USCG Clarification Request of May 8, 2007

Based on Calypso's March 9, 2007 data gap response (Response #1), clarify whether there are three or four alternative methods for cutting piles below the mudline during decommissioning. If four alternatives, describe the fourth method for cutting piles below the mudline.

Figure 9-1 Anchor Chain and Riser Affected Area

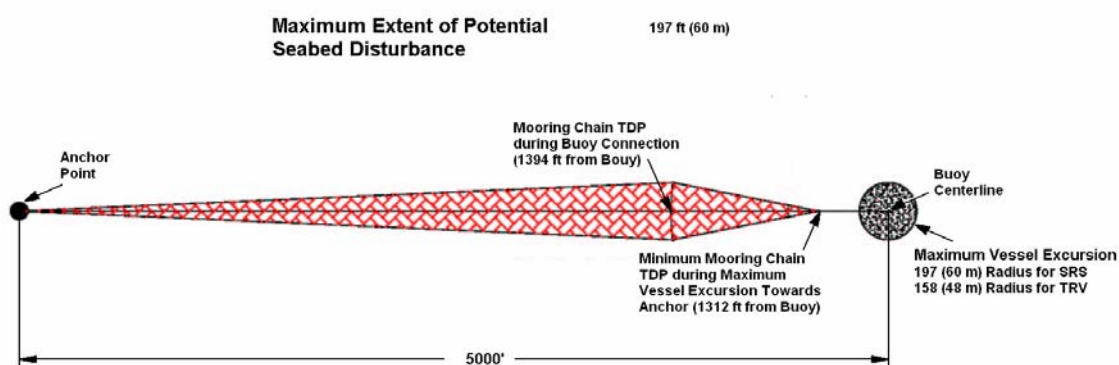
Expand the discussion of estimated acreage impacts to include the size of the construction area and permanent area occupied by the umbilical anchor, riser anchor, suction piles, and gravity anchors. Include technical drawings to illustrate typical gravity anchor installation. (Vol. II, Section 1.3.1.4, Pages 1-17 and 1-18 and Page 4-45).

Comparing total horizontal lengths of the chain on the seabed from the anchor to the initial TDP and the expected position of the anchor chain after vessel movement, a sweep pattern can be established. A general depiction of the expected area affected by the anchor chain is shown on Figure 9-1. The chain is conservatively assumed to sweep the area of the seabed from the chain's initial position to where the chain rests during the maximum excursion in each lateral direction. The chain movement in each lateral direction is conservatively assumed to be a straight line to form a triangle on each side of the initial chain position. As the buoy moves closer to the anchor, the distance of the anchor TDP from the buoy decreases. The lateral excursion of the anchor chain from its initial position also decreases. This is depicted by the second smaller set of triangles where the point closest to the buoy is the TDP of the chain since the maximum excursion of the buoy is in the direction of the anchor.

Figure 14-1 LNG Carrier (Typical) General Arrangement

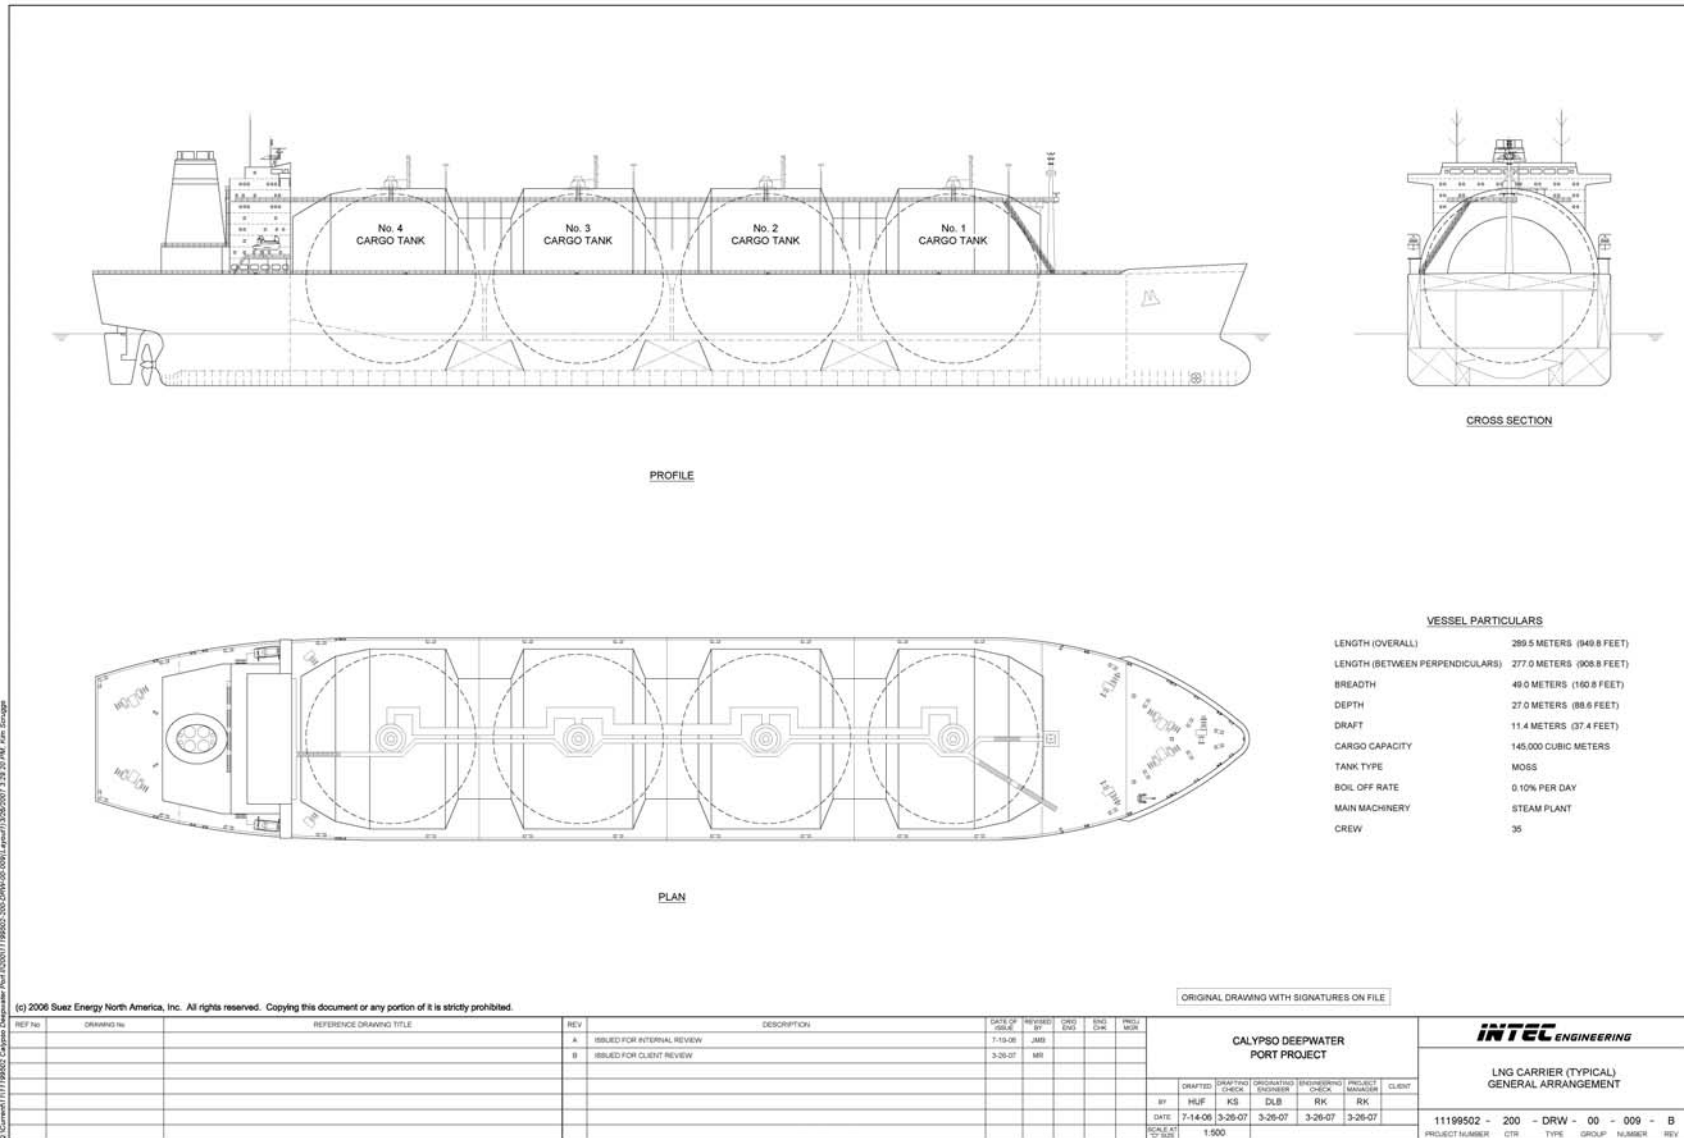
Provide a description and drawings of the typical LNG Carriers that would supply the SRS during operations, comparable to the discussion of the SRS and TRV operations in Section 1.6. (Volume II, Section 1.3.2 and 1.3.3)

Particulars of the typical LNG carrier are shown graphically in the attached General Arrangement drawing, Figure 14-1.
